PLANNING, ZONING, & BUILDING DEPARTMENT
PZ&B Staff Combination Memorandum: Architectural Commission and Town Council

SUBJECT: ARC-24-0133 (ZON-24-0074) 410 SEABREEZE AVE (COMBO)

MEETING: JANUARY 29, 2025, ARCOM
FEBRUARY 12, 2025, TC

Existing and Proposed Rear (South) Elevations

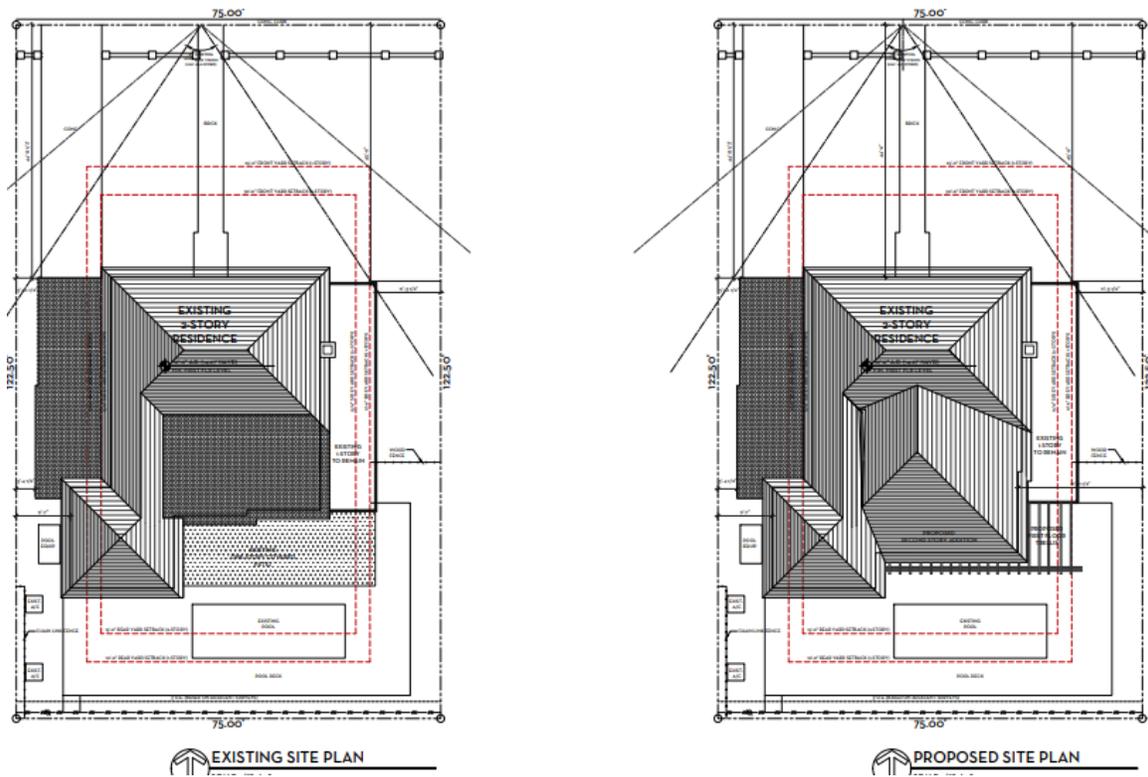
The application is for a proposed addition. The proposed improvements to the structure are within the existing footprint. The applicant is proposing a second story addition at the existing second floor balcony on the rear east side of the structure. The addition is relatively small (178 SF); however, variances are required to achieve the scope of work. The roof of the addition will be a hip that ties into the existing roof surfaced in matching tile. This will eliminate the currently flat roof portion of the house. Exterior finishes include wood siding to match the existing, multi lite windows flanked by painted wooden shutters and French Doors facing the rear.

The design requires two variances as proposed.

- **VARIANCE 1: Sec. 134-893(b)(11) b.:** A variance to rebuild a ground floor terrace and a second story addition with a 31.4% lot coverage, in lieu of the 30% maximum lot coverage permitted.
- **VARIANCE 2: Sec. 134-893(b)(13):** A variance to permit a cubic content ratio of 4.59 in lieu of the 4.45 existing and the 4.08 maximum CCR permitted.

As it pertains to VARIANCE 1, the rear of the structure is being removed to construct a more cohesive dining room and covered outdoor seating downstairs and a new dressing room upstairs. Due to the extent of demolition of this portion of the house the lot coverage will need to be revisited through a variance despite decreasing the lot coverage from 31.7% to 31.4%.

Axonometric diagram of cubic content from rear.

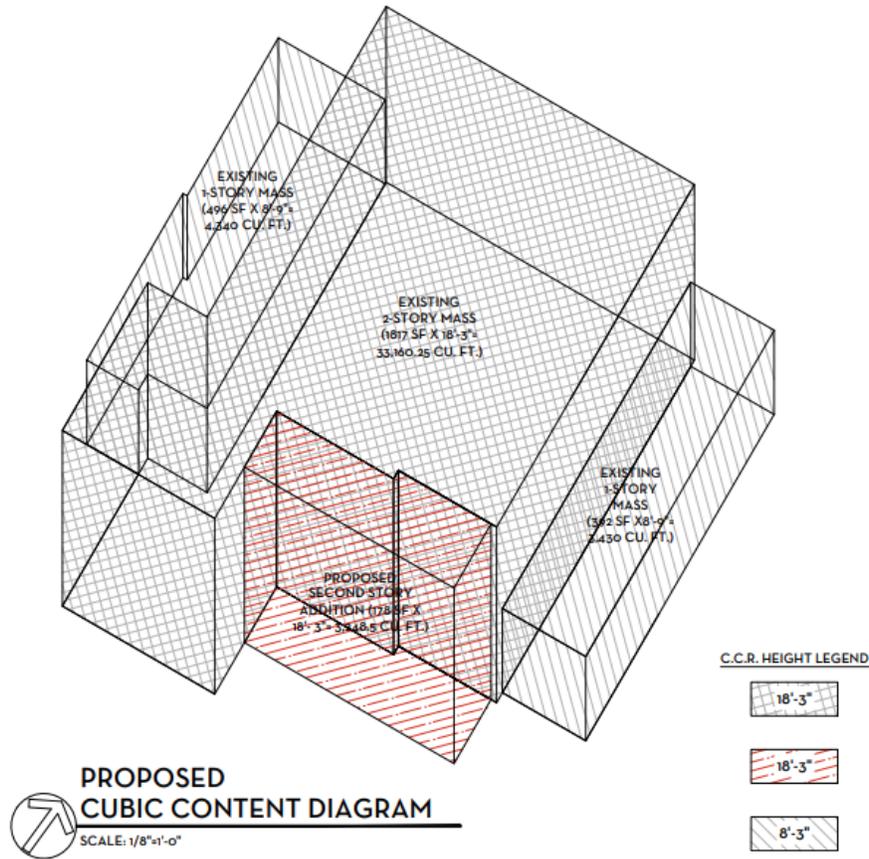
Variance 2 is to exceed the maximum cubic content ratio (CCR) permitted on site. As mentioned previously, the structure was built in the 1930s and therefore prior to today's zoning code. In 2008, the Town Council considered and granted a variance for a similar scope of work as it pertained to first and second floor additions to the nonconforming building, which permitted the expansion of the already nonconforming cubic content ratio (CCR) to the 4.59 amount existing today.

The size of the addition is approximately 178 SF at 18.3' in height for that volume, adding an additional 0.14CF of mass to the already nonconforming structure. The addition will not be visible from the public right of way nor the west elevation and matches the existing structure in style and materials. While the relatively small second floor addition seamlessly blends in with the architecture of the 1930's residence, it still remains as a variance and its approval needs to provide hardship in order for the Town Council to grant. Perhaps, as the Code reform continues to examine all aspect of the zoning code, the Town Council could provide specific direction on a lesser standard of approval for CCR on older residential buildings in the Town as a means of further incentivizing their retention.

Code Section	Permitted	Proposed	Variance
VARIANCE 2: Sec. 134-893(b)(13)	4.08 Max CCR	4.59 CCR in lieu of 4.45 CCR existing	+0.14 CCR from exist. +0.37 CCR from max.
